TVA-TS-447

**BROWNS FERRY NUCLEAR PLANT (BFN) - UNITS 1, 2, AND 3 -
TECHNICAL SPECIFICATIONS (TS) CHANGE TS-447 SECOND REQUEST
FOR ADDITIONAL INFORMATION (RAI) - EXTENSION OF CHANNEL
CALIBRATION SURVEILLANCE REQUIREMENT PERFORMANCE
FREQUENCY AND ALLOWABLE VALUE REVISION (TAC NOS. MC4070,
MC4071, and MC4072)**

BROWNS FERRY (BFN) TS-447 REQUEST FOR ADDITIONAL INFORMATION (RAI) Response to the August 15, 2005 RAI

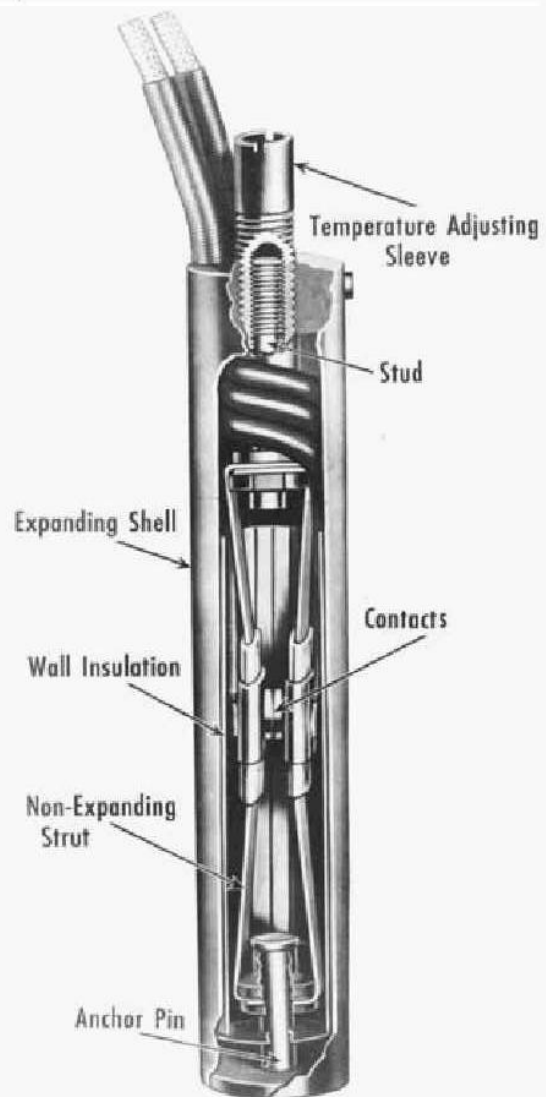
The physical construction of the device shown at right basically consists of a shell and two contact carrying struts. The shell and struts have different thermal growth rates. None of the materials or the basic construction of the devices would indicate a propensity to drift.

The picture at right depicts normally closed (NC) contacts that pull apart when the shell grows with temperature. The normally open (NO) contacts are arranged such that they pull together when the shell grows in length with temperature. The slight difference in the strut arrangement for the NO and NC contacts would expectedly result in a difference in the repeatability (variability) of the two types of Thermoswitch (NO vs NC). The HPCI/RCIC switches are NO, and the MSL switches are NC.
